## Staff Report

To: BOZAR  
From: Jessie Earley, Town Planner III  
Meeting Date: DRC, January 13, 2025  
RE: 422 and 422 ½ Sopris Avenue, Secondary Review

**PROJECT TITLE:** Breuer Residence (422 Sopris Avenue)

**Proposed Site Plan (1/13/2025 DRC)**

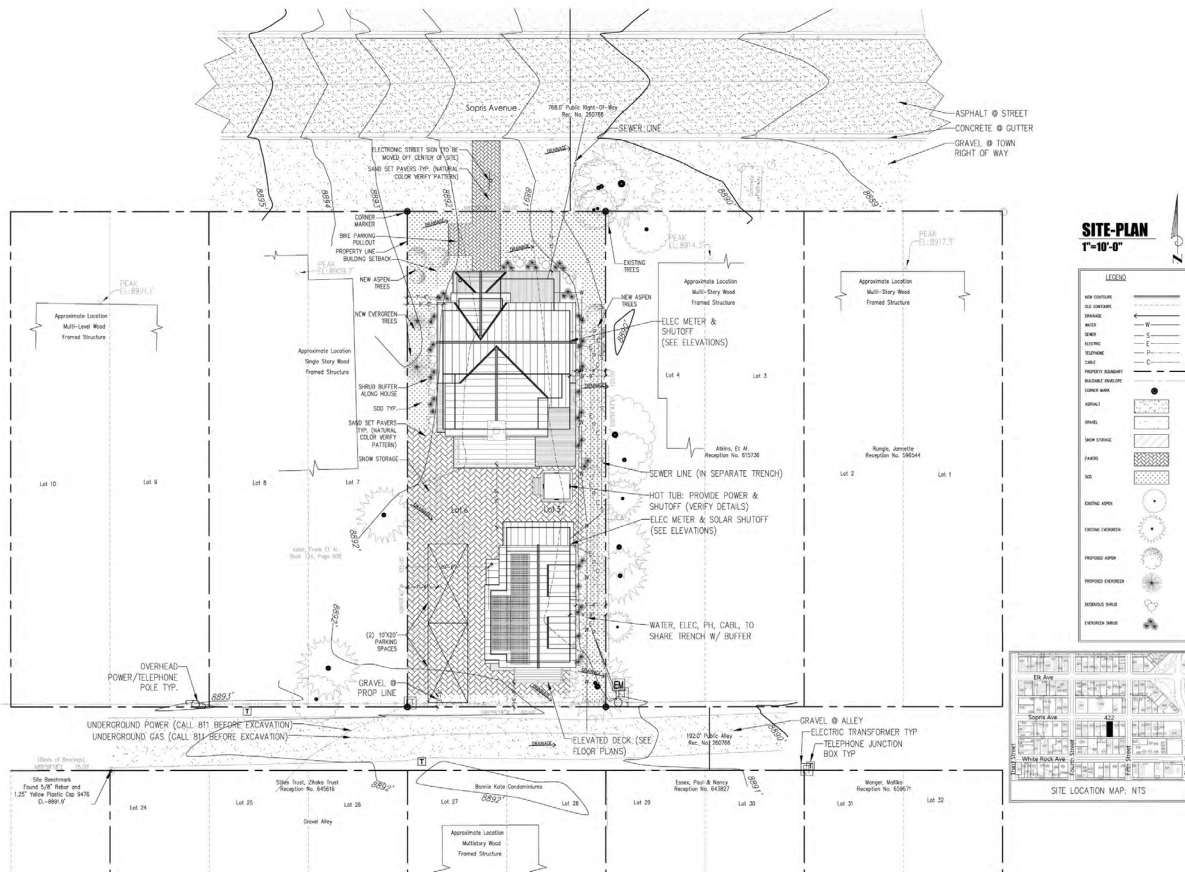
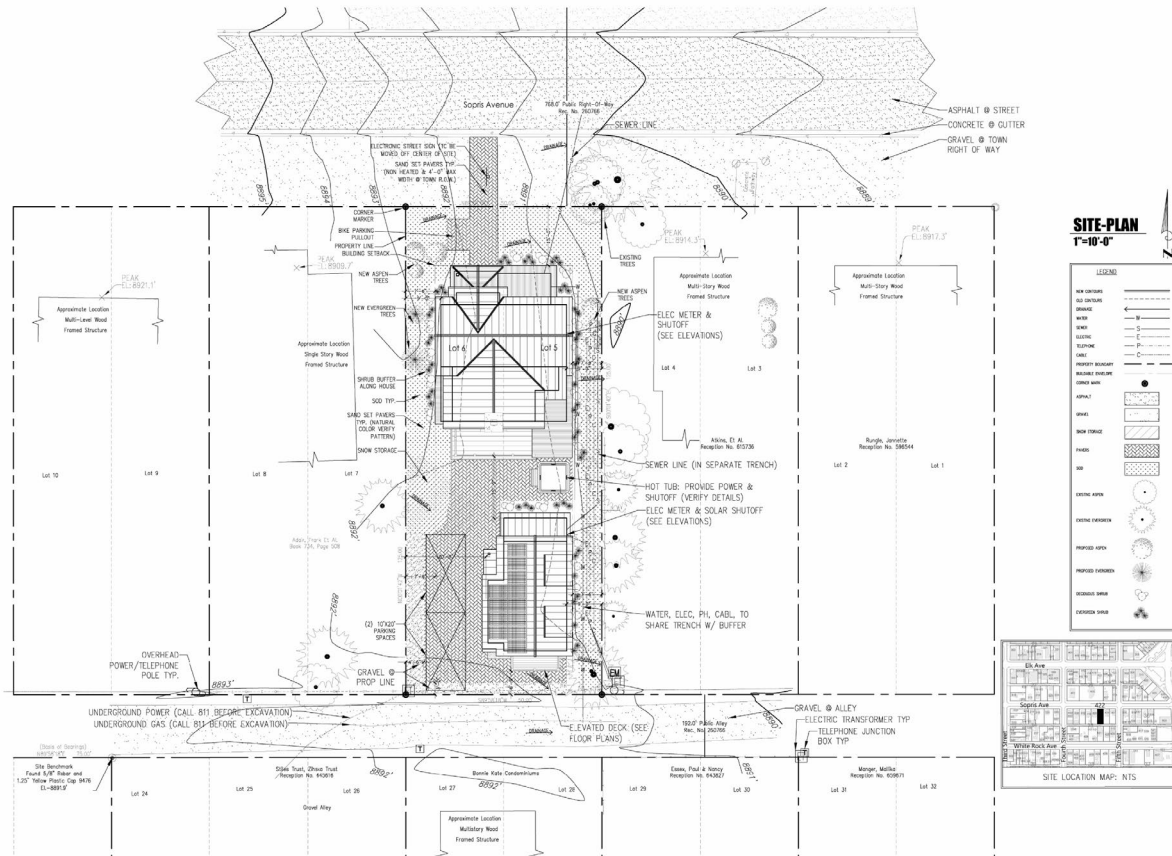
2.8 Drainage	<b>Drainage swales are shown for the primary and accessory building to the east. However, drainage will need to be revised to encourage drainage to the alley or the street not the adjacent lot.</b>  <b>A dry well is now shown on the north side of the lot. This will need to meet the specifications required by the Public Works Department.</b>	12/9 DRC: Drainage cannot be to the neighboring property. Revisions needed
Easements	NA	NA

2.16 e Pervious materials	<p><b>There is a small area of gravel on the south side of the lot adjacent to the alley.</b></p> <p><b>The south portion of the lot and between buildings is called out as sand set pavers and was reduced from (2125.07 sf) to (1286.35 sf). It is appreciated that the material is pervious.</b></p> <p><b>There is a walkway and bike parking pull out on the north side of the lot, which extends into the right of way that is also noted as sand set pavers (274.76 sf). The width of the sidewalk on the north cannot exceed 4' into the ROW and cannot be heated.</b></p>

2.28 e & f Parking substrate	Parking spaces are noted as sand set pavers, which meet the intents of the GL. General support.	Support
(2.37-2.40)/ 16-17-40 Exterior Lighting	Proposed lighting appears to comply with night sky requirements. General support.	Support
Solar	There is solar proposed for the west roof face of the ADU, which meets the intents of the GL.	Support
Utilities	<b>Wet and dry utilities have been included on the site plan. Water and sewer lines should not be located on the same side of the home (east), as noted. They should be separated</b>

and sewer should move to the west side of the home.  If a lift station is required, it would need to be included on the interior of the structure.  Adjacent rights of way are included to scale.	
2.7 Snow Storage	Snow storage is provided onsite and is over the minimum of 33%. The areas correspond with areas to be plowed.	Support

- Site:
  - Reduced the number of pavers in three ways.
    - Pulled them from the West property line at the parking area.
    - Added more grass West Side of the property under the snow storage.
    - Pulled the pavers back from the North side of the garage & added plantings.
  - Added a Dry Well to the North of the property.
  - Provided a “tree plan”.
- House:
  - Removed the exterior stone fireplace. Reduced the chimney to a 30”x30” stone square coming through the ridge. Increased the door & window width as well as adding a south facing window in its place.
  - Separated mulled windows by at least 6” between.
  - Separated three packs of windows by 12” between.

### Rear porch (1/13/2025 DRC)

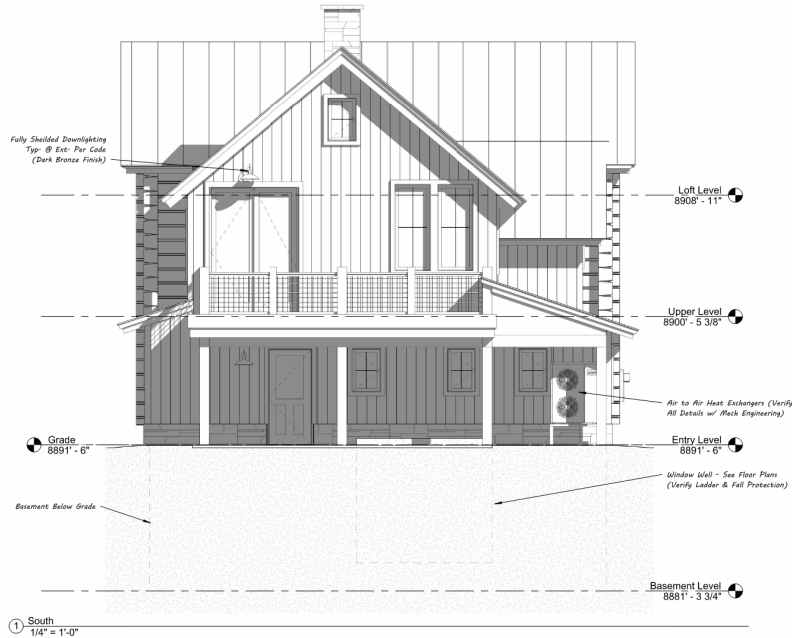
GL	Staff Analysis	DRC Recommendation
4.49/5.118 Primary entrance porch	These GL encourage clearly defining the entry, which is done in many cases with a porch as seen on many historic buildings and also on this building. General support.	Support
4.50 Mix of porch sizes	The front porch is 8'x10'6", which meets the intents of this GL.	Support
4.51 Rear entry porch	The porch on the rear is simpler with the shed than the front porch, as asked for in GL 4.51.	Support

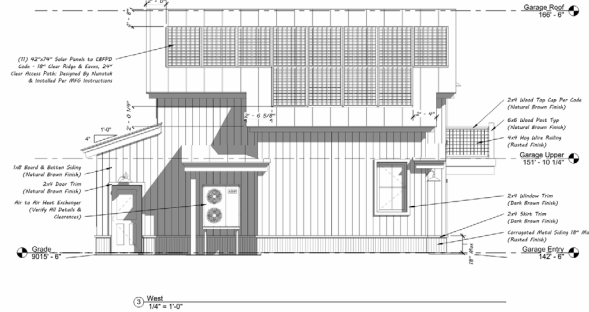
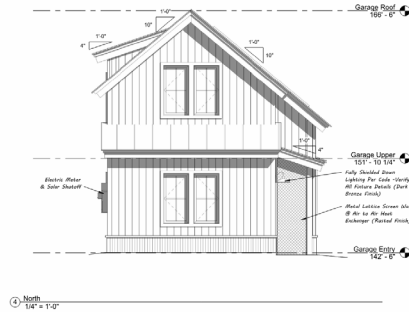
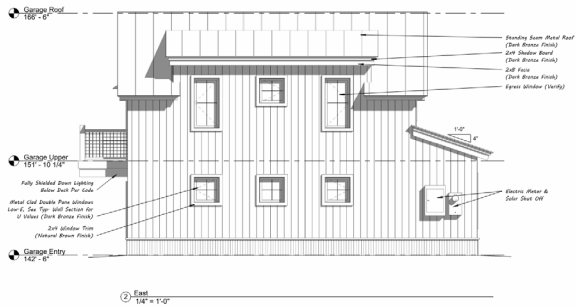
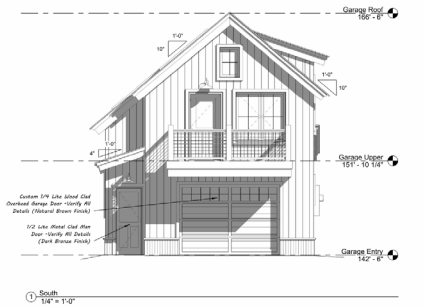
GL	Staff Analysis	DRC Recommendation
4.71 Chimneys	<b>The oversized chimney was removed and is now a small chimney from the roof, as would have been seen historically.</b>	12/9 DRC: members voiced concerns regarding the large oversized chimney on the south. This has been revised.

4.72 Eaves	Eaves are between 10" and 1'6", which meets the intents of the GL.	
4.75/4.76 Exterior materials	Per GL 4.76 c, plank and chink siding is not allowed in core zones. Discussion is encouraged to determine if this meets the intents of this GL.  The vertical siding meets the intents of this GL.	12/9 DRC: Members felt that the siding was a log siding not plank and chink and this was not a concern.

4.75 Exterior materials	Per GL 4.75 e and 4.80 a, the dry stacked stone can be supported at 18". General support.	Support
4.79 Painted siding	Natural finishes are proposed, which appears to conflict with this GL, as it requires paint or stain.
